ADDENDUM NUMBER TWO

ZONE 41 MINGUS PUMP STATION, TANK AND PIPELINE

DATE OF ADDENDUM: April 15, 2024

DRAWING NUMBER: **I-604**
 SHEET NUMBER: 82 OF 84

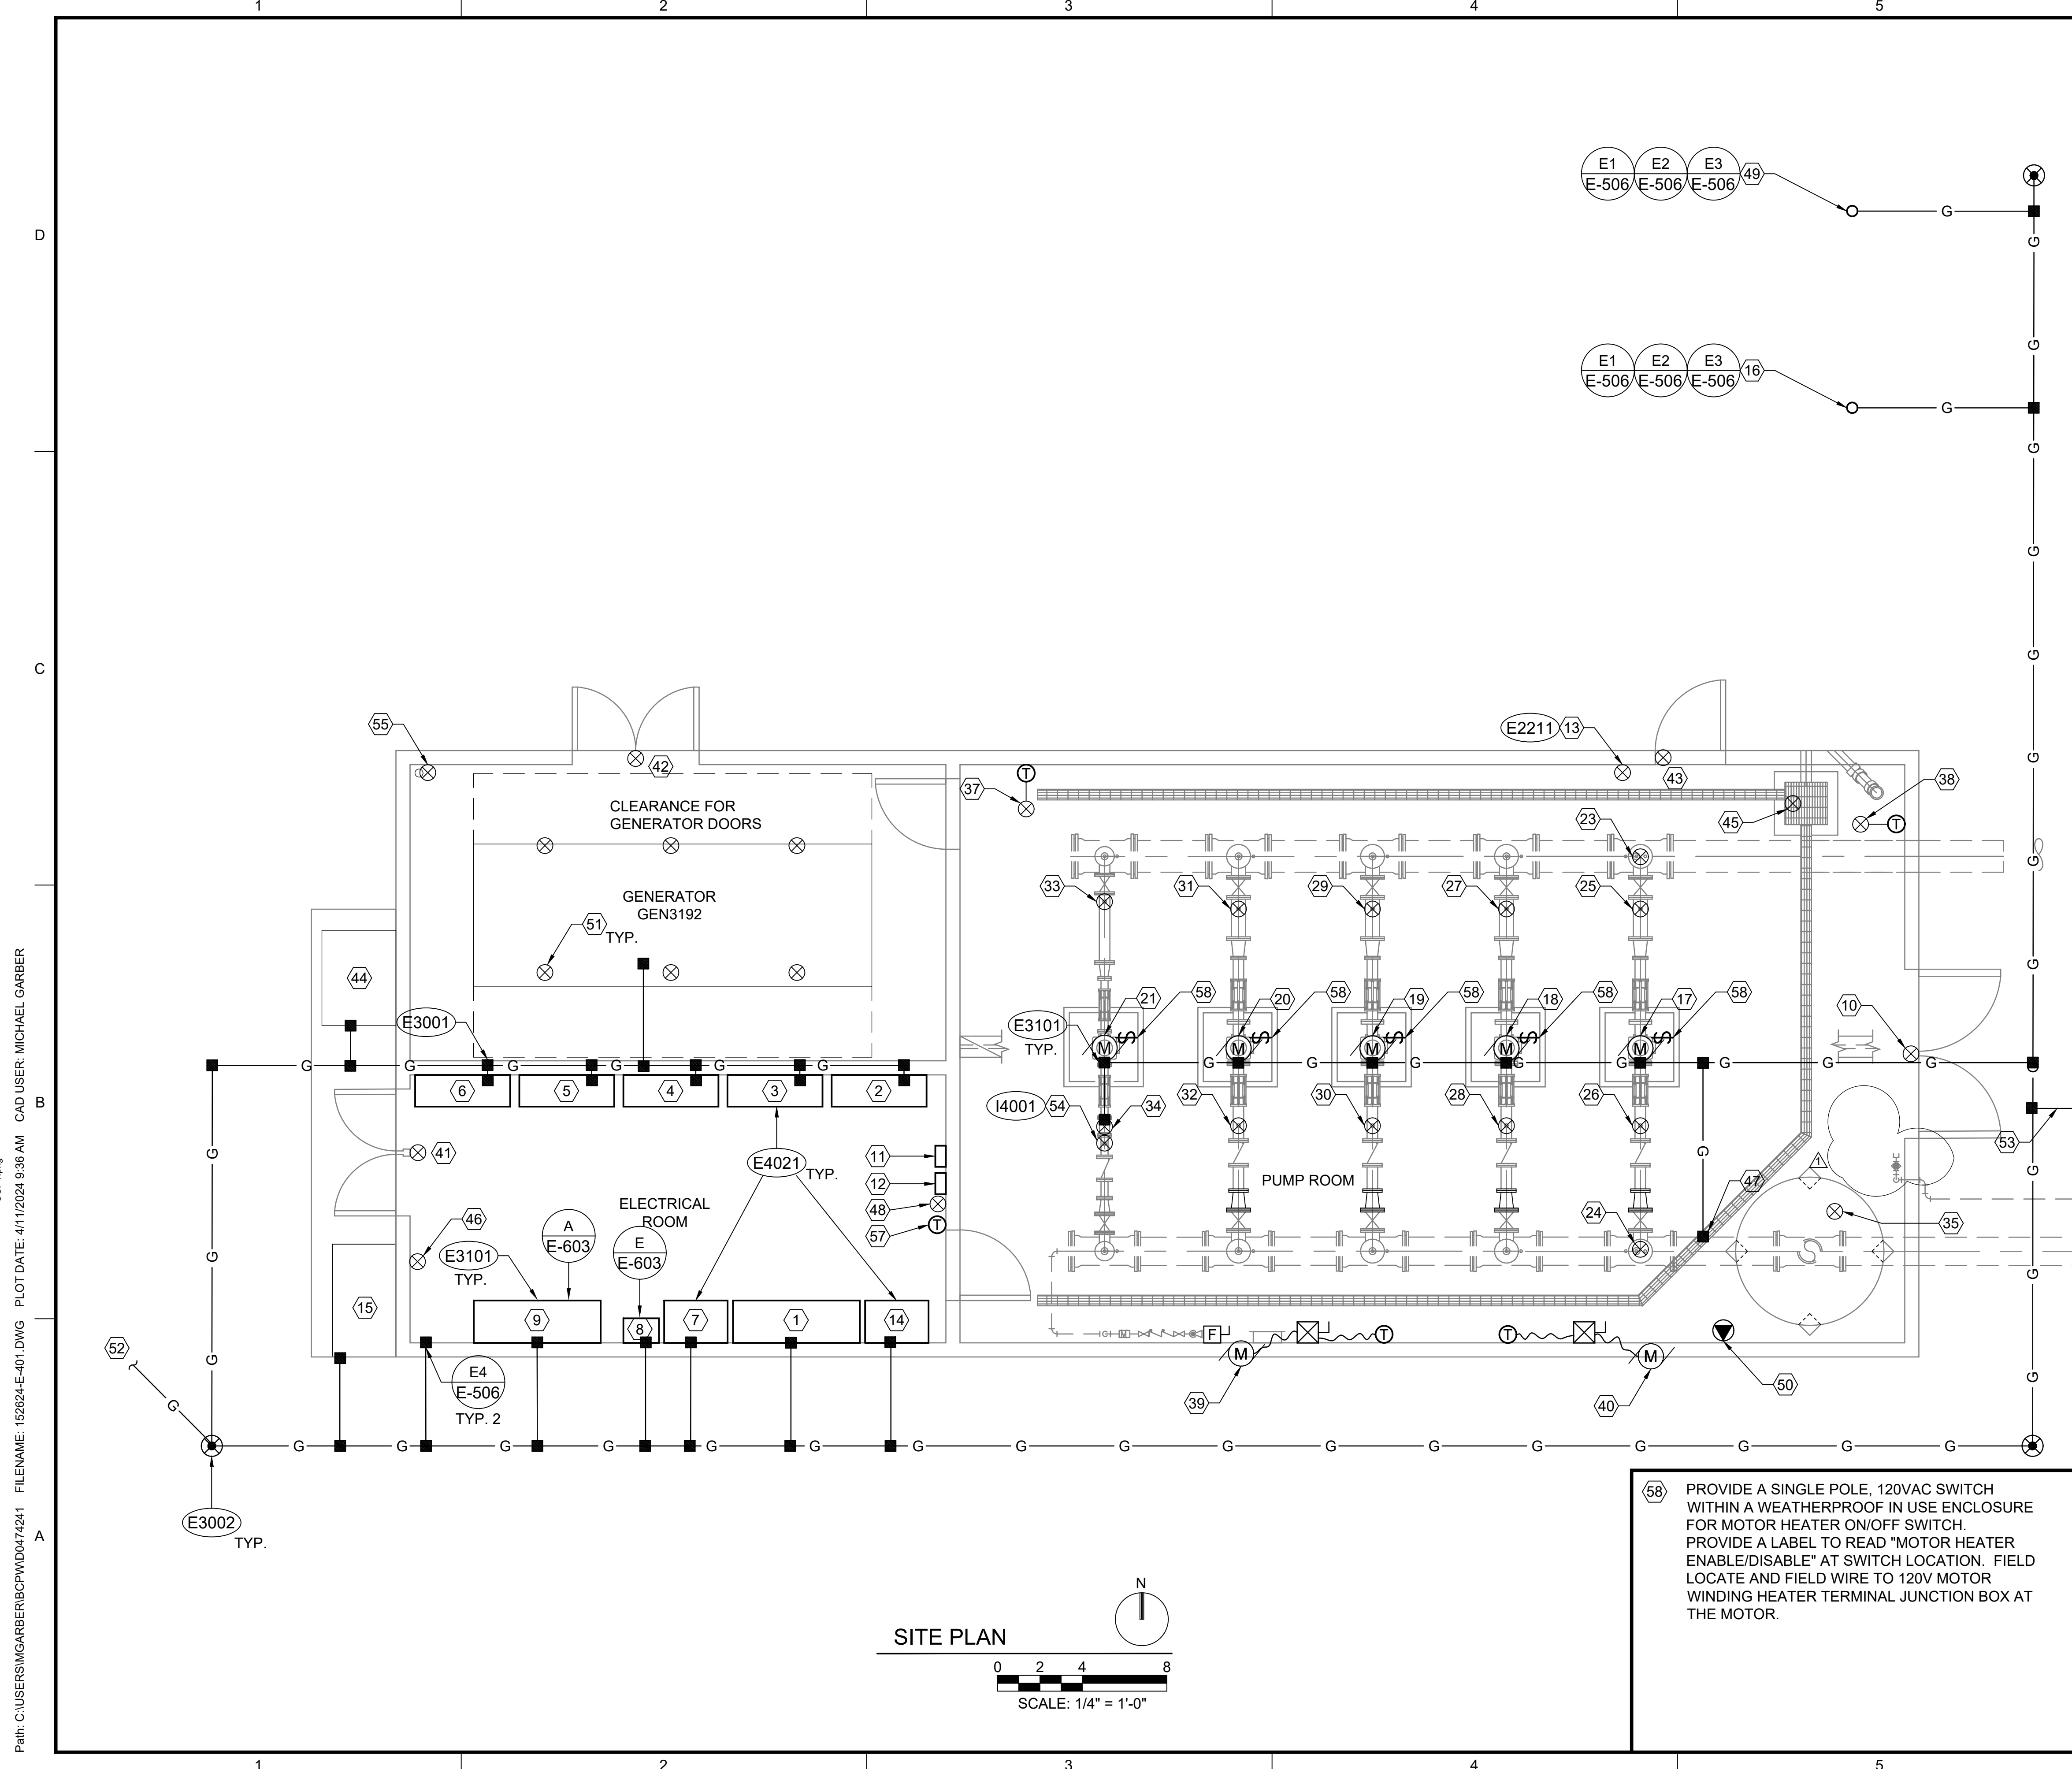
Question: In reference to spec section 43 42 21 Bladder-Type Hydropneumatic Tanks, Charlotte Tank has requested an alternative approach to accessories and operational instrumentation.

Response: No exceptions as Specification Section 40 73 00 specifies a Rosemount for pressure (this is differential pressure) and a pressure indicating transmitter, PIT-3160, is to be provided per Contract Drawing I-602 by others.

Response: Refer to the revised plans listed in the ‘Changes to Project Plans’ section.

DRAWING NUMBER
E-401
 SHEET NUMBER
 60 OF 84

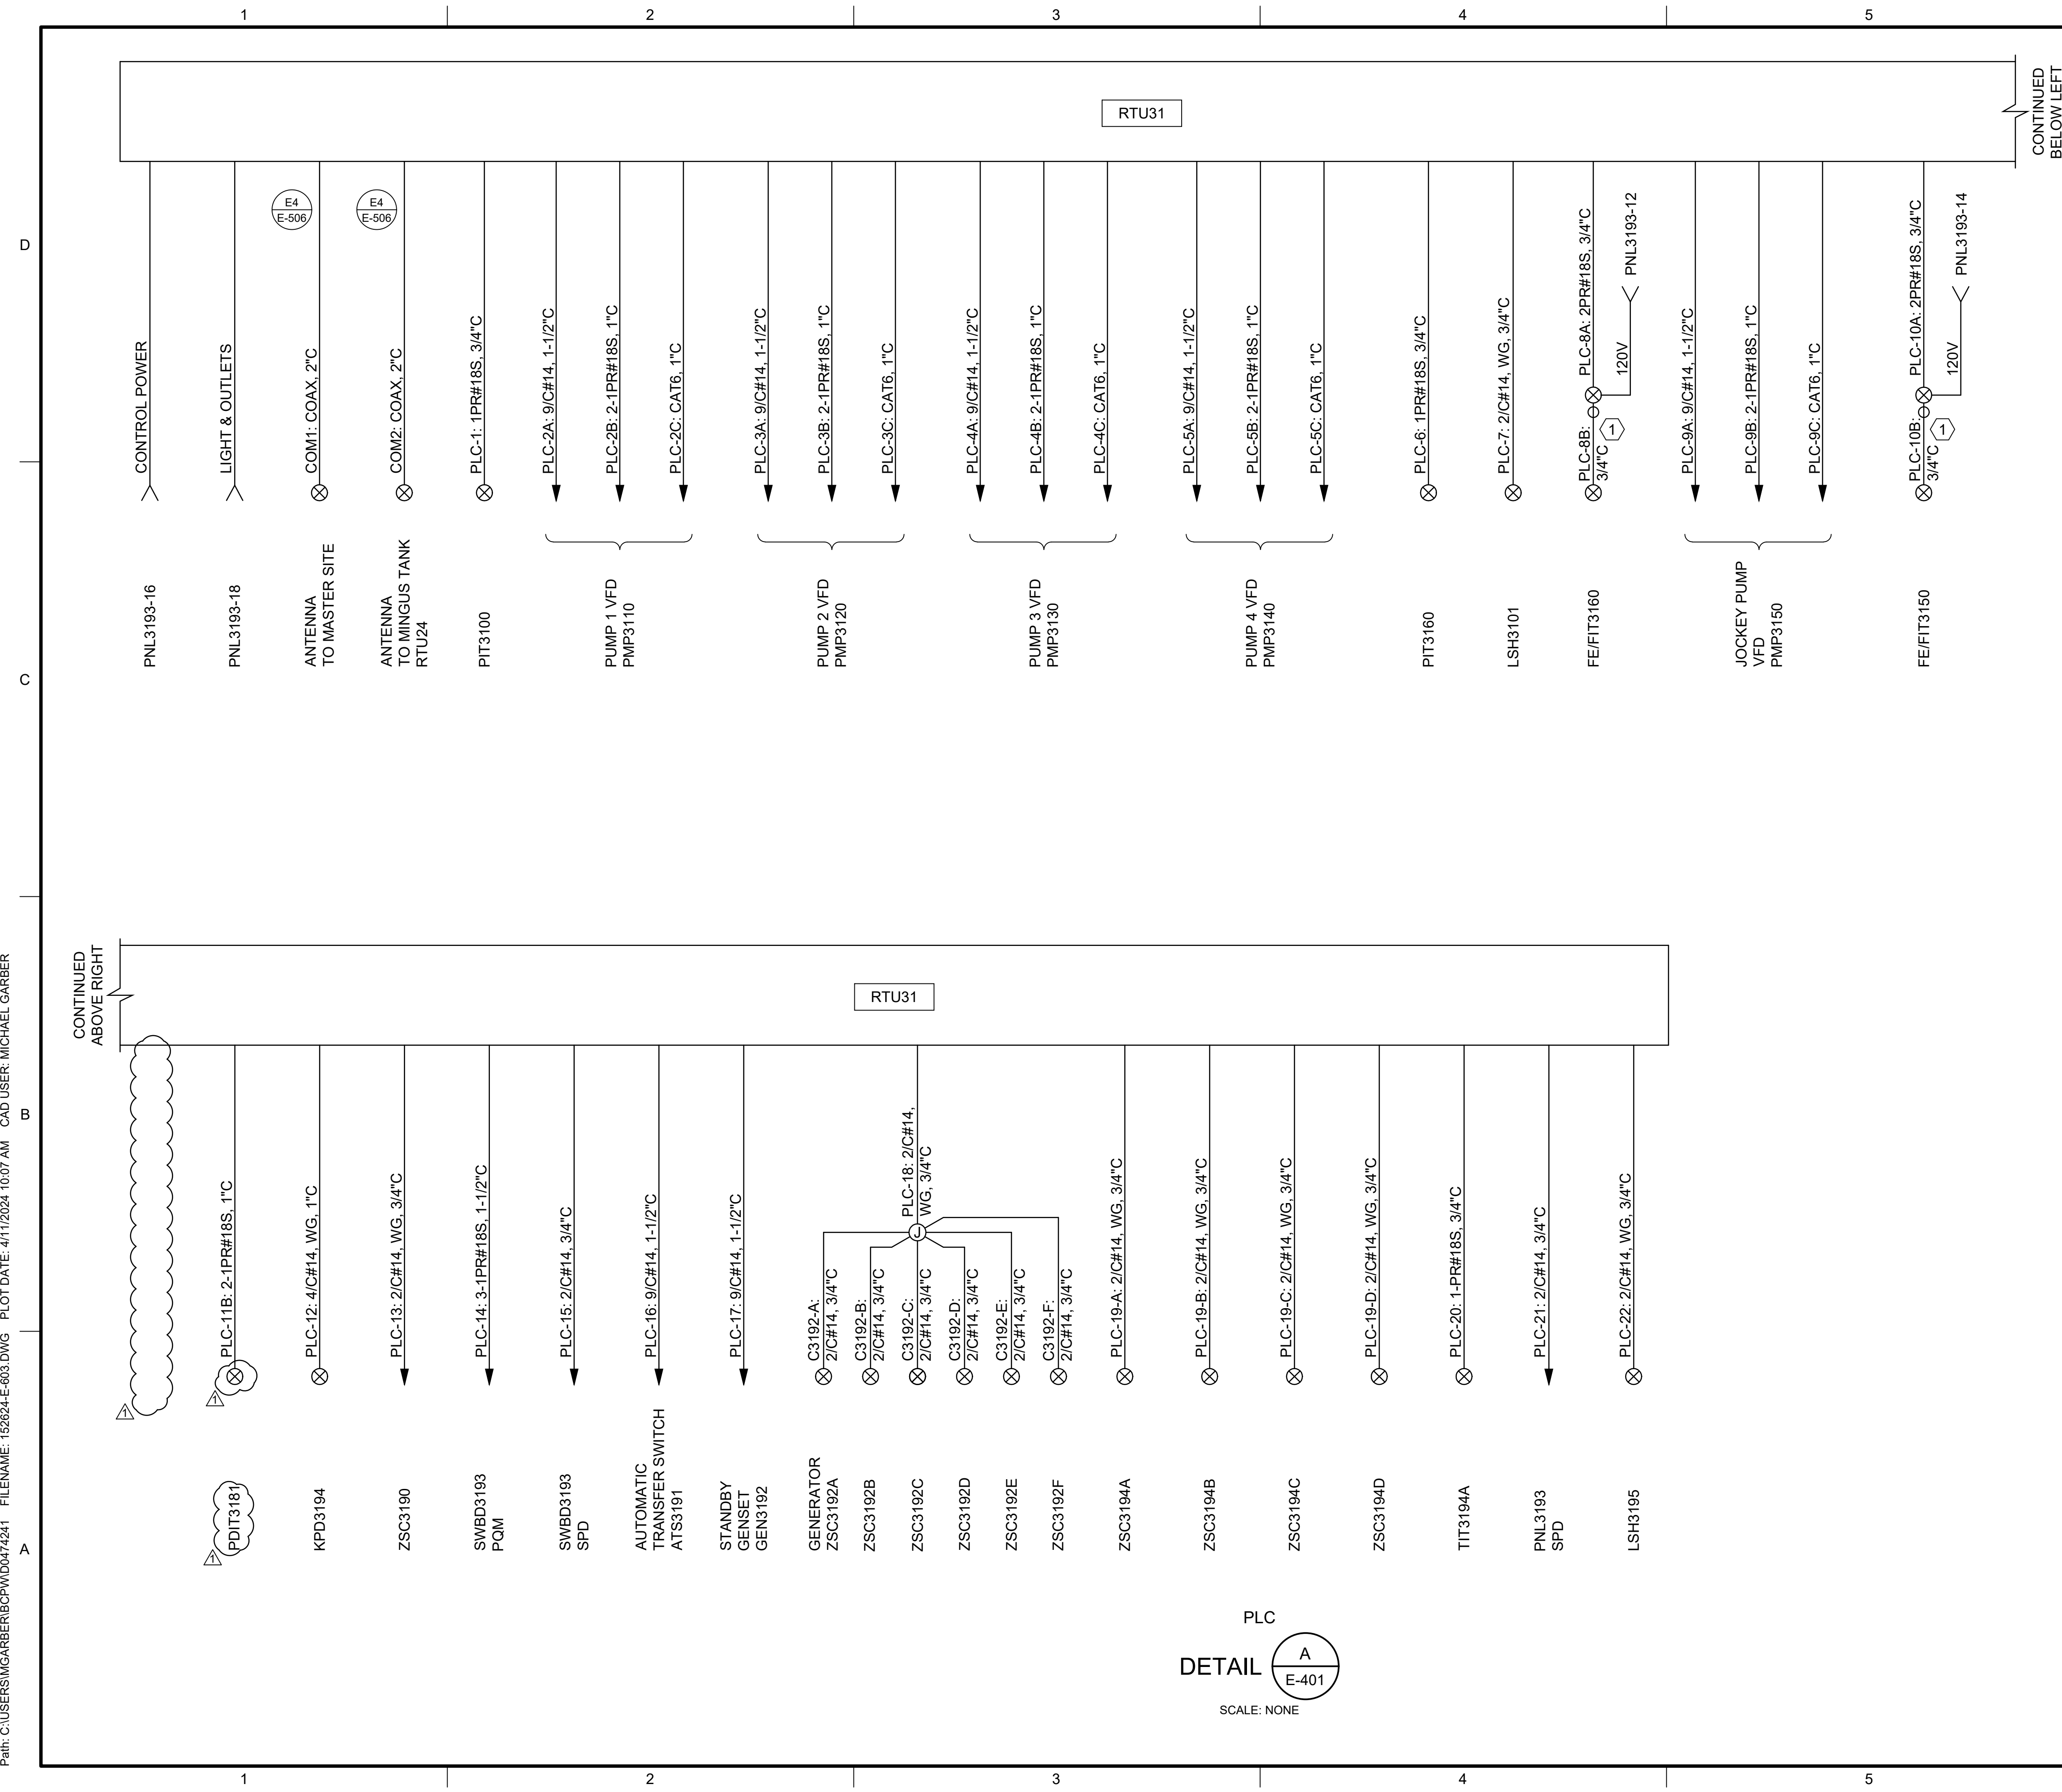
1. **Remove and Replace:** Plan Sheet No. 60, Drawing E-401, Pump Station Enlarged Plan with revised plan sheet (attached).
2. **Remove and Replace:** Plan Sheet No. 70, Drawing E-602, Pump Station Load Summary and Schedules with revised plan sheet (attached).
3. **Remove and Replace:** Plan Sheet No. 71, Drawing E-603, Pump Station Control Single Line Diagram with revised plan sheet (attached).
4. **Remove and Replace:** Sheet No. 82, Drawing I-604, Surge Tank Process and Instrumentation Diagram with revised sheet (attached).
